2.2 Control and Instrument Systems

The information in this section of the reference ABWR DCD, including all subsections, tables, and figures, is incorporated by reference with the following departures.

Figure 2.2.1 Rod Control and Information System Control Interface Diagram

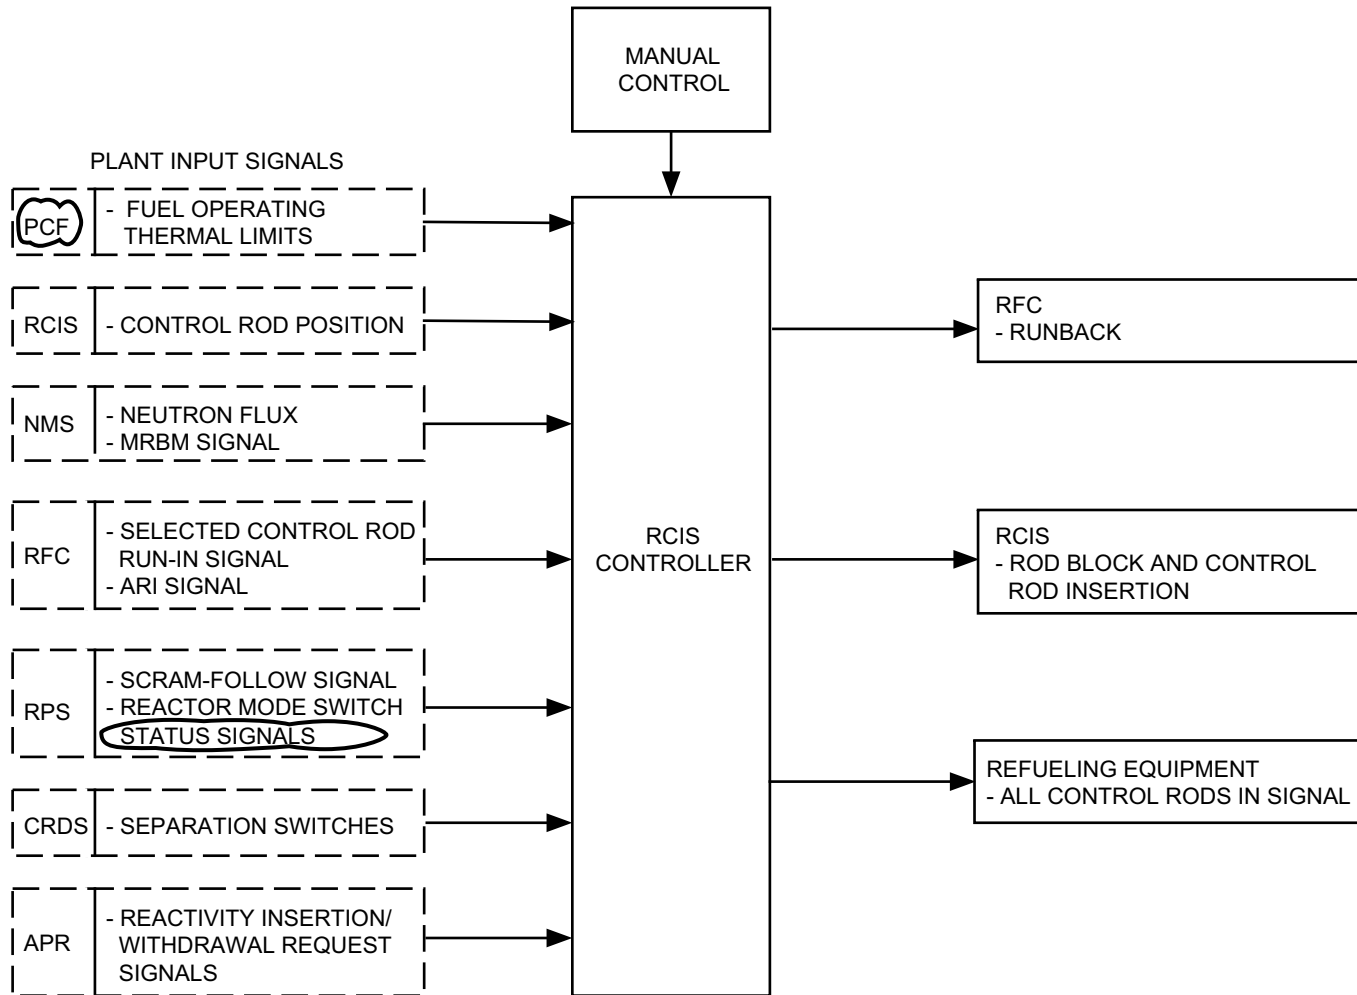
STD DEP T1 2.2-1 (Figure 2.2.1—RPS, Table 2.2-1—Item 8)

STD DEP T1 3.4-1 (Figure 2.2.1—PCF)

- (6) *An automatic control rod withdrawal block in response to:*
 - (b) *A signal from the CRD System FMCRD hollow piston/ball nut separation switches (withdrawal block applies only to separated control rod if the associated control rod is selected for movement when the RPS Mode Switch is in the Startup Mode or Run Mode), or*

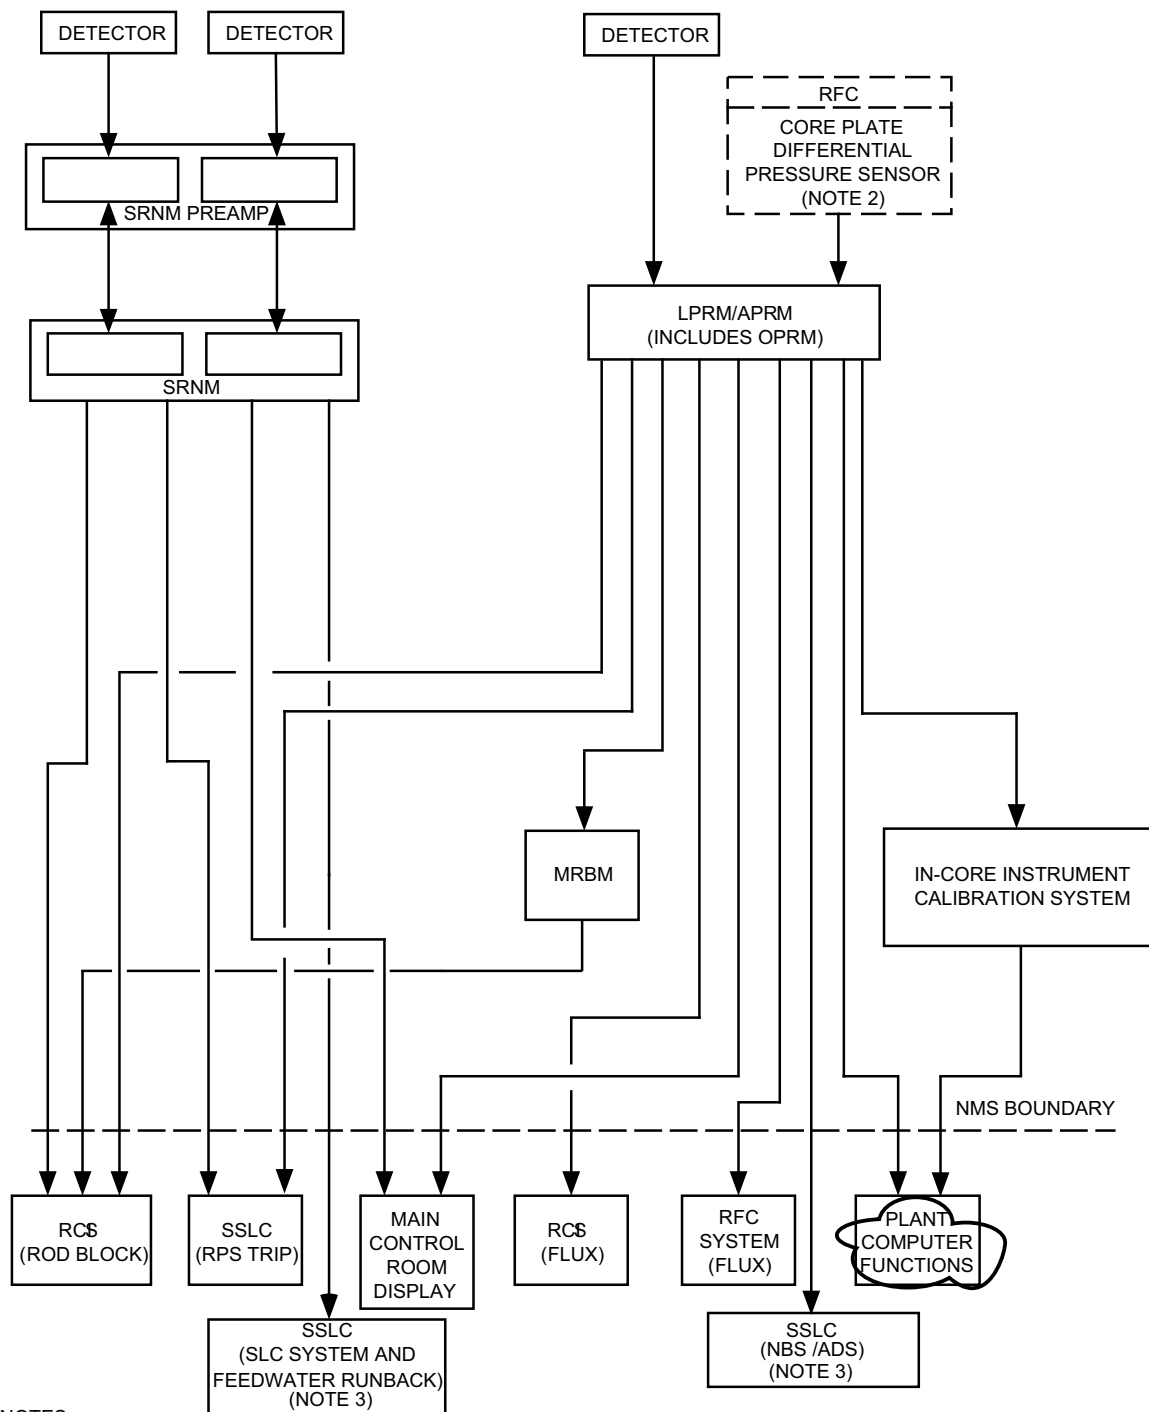
The FDWC digital controllers determine narrow range level signal using three reactor level measurement inputs from the NBS. ~~Sensor signals are transmitted to the FDWC digital controllers by the Non-Essential Multiplexing System (NEMS).~~

The steam flow in each of four main steamlines is sensed at the RPV nozzle venturis. ~~Sensor signals are transmitted to the FDWC System digital controllers by the NEMS.~~ These measurements are processed in the digital controllers to calculate the total steam flow out of the vessel.

Feedwater flow is sensed at a flow element in each of the two feedwater lines. ~~Sensor signals are transmitted to the FDWC digital controllers by the NEMS.~~ These measurements are processed in the digital controllers to calculate the total feedwater flow into the vessel.

Figure 2.2.7a Reactor Protection System Control Interface Diagram

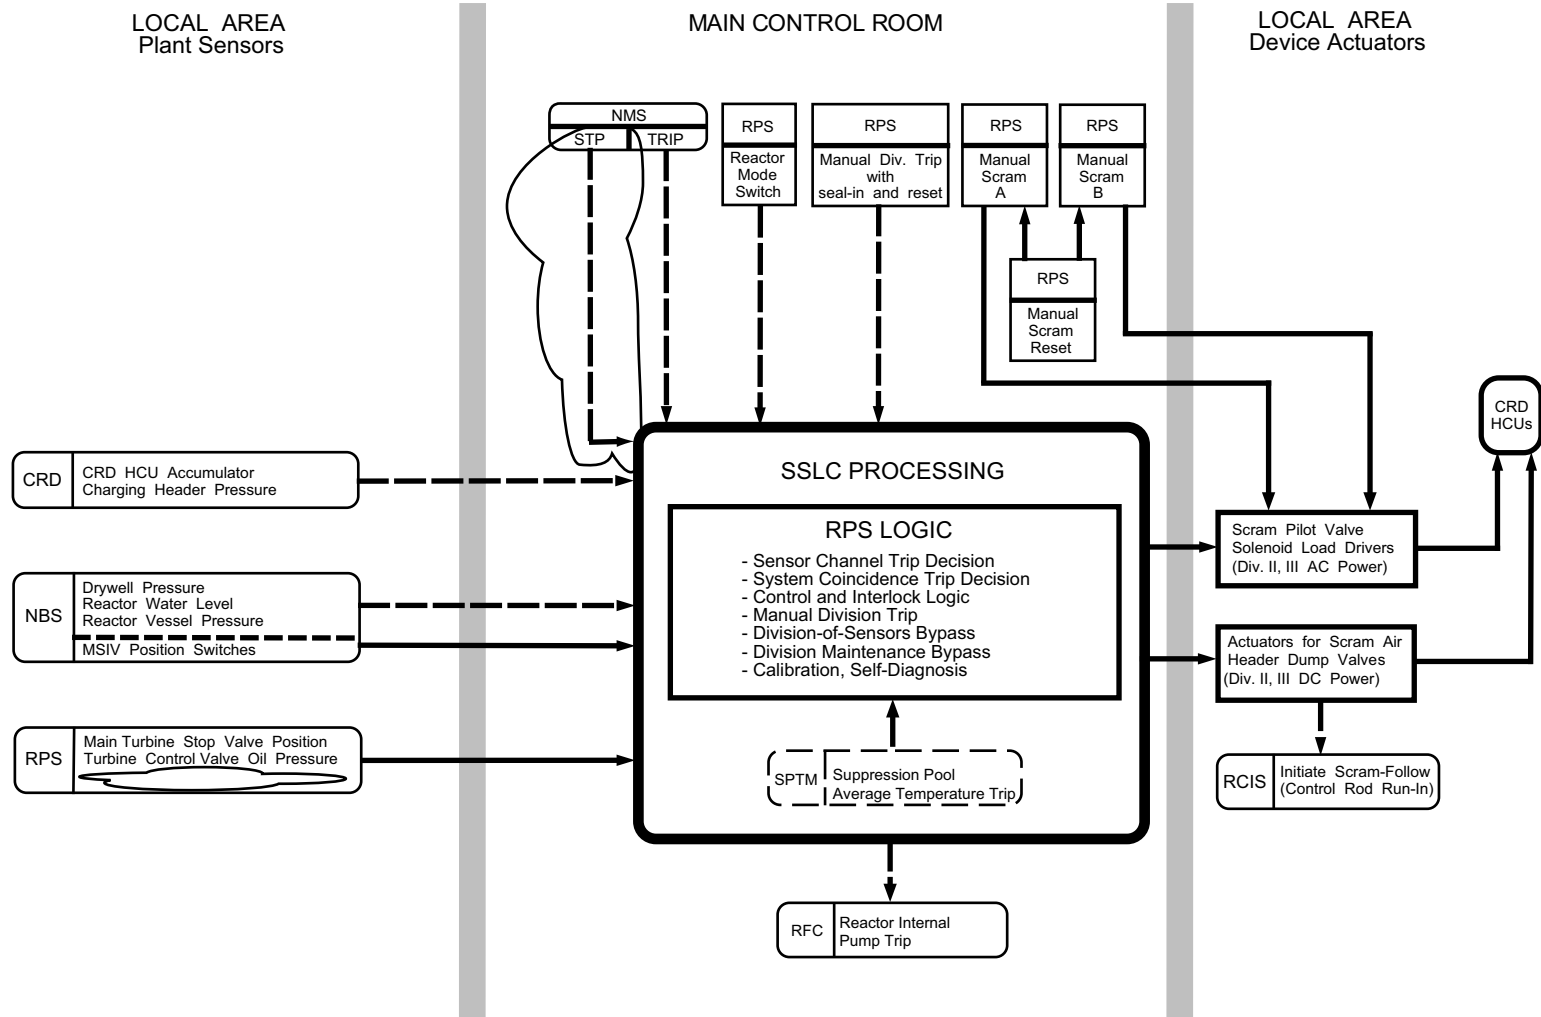
STD DEP T1 2.2-1 (Figure 2.2.7a, Table 2.2.7)

As shown in Figure 2.2.7a, the RPS interfaces with the Neutron Monitoring System (NMS), Nuclear Boiler System (NBS), Control Rod Drive (CRD) System, Rod Control and Information System (RCIS), Recirculation Flow Control (RFC) System, and the Suppression Pool Temperature Monitoring System (SPTM), ~~and the Essential Multiplexing System (EMS)~~. Figure 2.2.7a also depicts the primary implementation of RPS logic within the Safety System Logic and Control (SSLC).

RPS initiates a reactor internal pump (RIP) trip on receipt of either a turbine stop valve closure or a low turbine control valve oil pressure signal when the reactor power is above 40% (from ~~a turbine first stage pressure~~ NMS STP signal).

Figure 2.2.7b Reactor Protection System

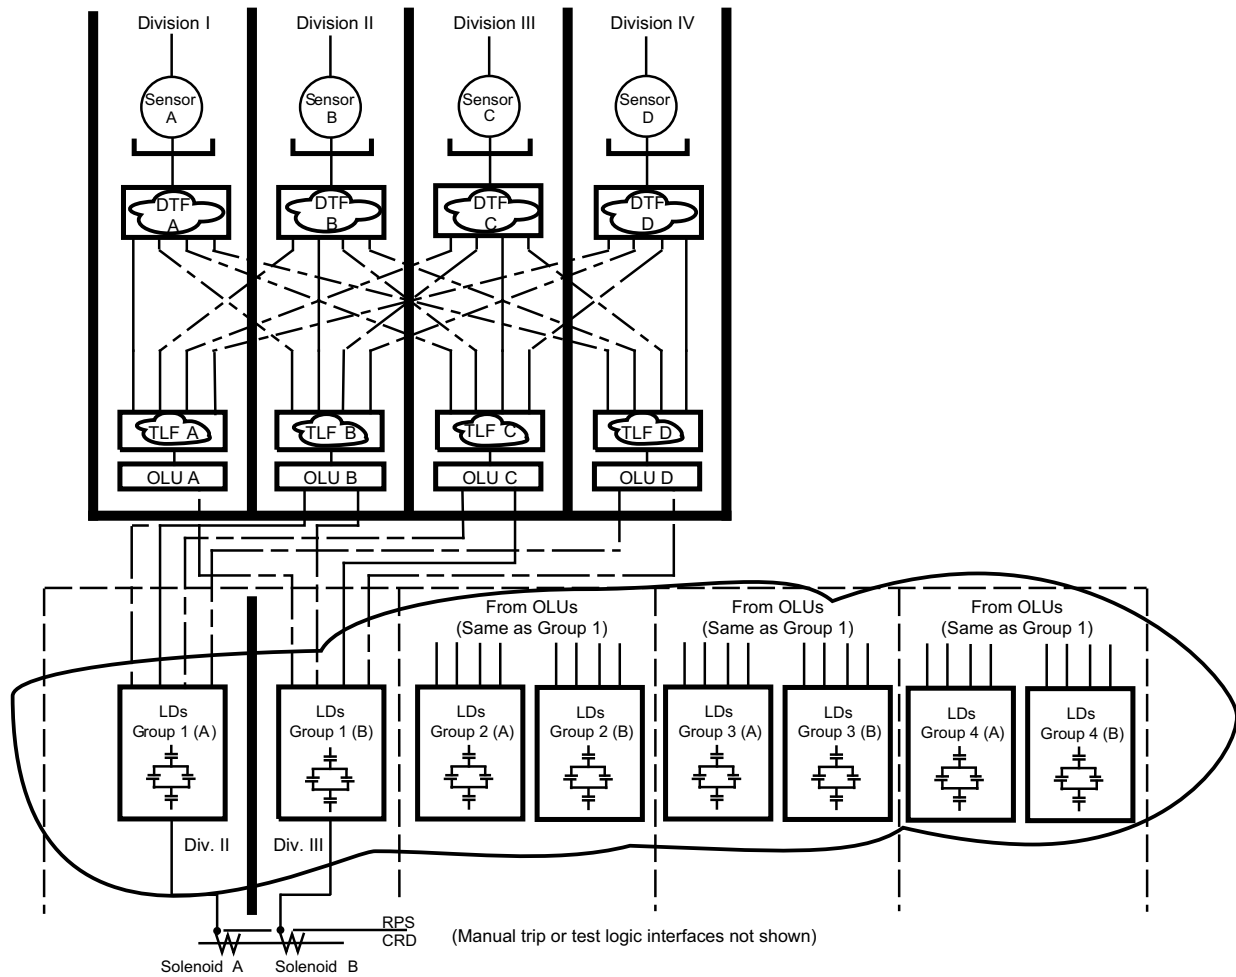
STD DEP T1 3.4-1 (Figure 2.2.7b)

The RPS has four divisions. Figure 2.2.7b shows the RPS divisional aspects and the signal flow paths from sensors to scram pilot valve solenoids. Functions Equipment within an RPS division consists of include sensors (transducers or switches), multiplexers, data communication, digital trip modules functions (DTM DTF), trip logic unit function (TLU TLF), output logic unit (OLU), and load drivers (LD). The LDs are only in Divisions II and III. The (DTF) and (TLF) are performed in digital control processors. The data communication functions are described in Section 2.7.5.

The RPS consists of logic and circuitry for initiation of both automatic and manual scrams. The automatic scram function is accomplished redundantly in four independent divisions of sensor instrument channels, hardware/software based logic and logic processing, and two independent divisions of actuating devices. Automatic scram is initiated whenever a scram condition is detected by two or more automatic divisions of RPS logic. ~~For automatic scram, the sensor input signals to the RPS originate either from the RPS's own sensors or other systems' sensors. For determination of the existence of an automatic scram condition, within each automatic scram channel division of the RPS, the DTM DTF of a given RPS channel division compares the monitored process variable with the a stored setpoint stored in its memory and issues a trip signal if the monitored process variable exceeds the setpoint. The DTM DTF then sends the trip signal to the TLU TLF of its own channel division and the TLU TLFs of the other three channels divisions of RPS, where two out of four voting is performed (see Figure 2.2.7b). The TLF in each division performs an independent two-out-of-four vote on each RPS DTF input.~~
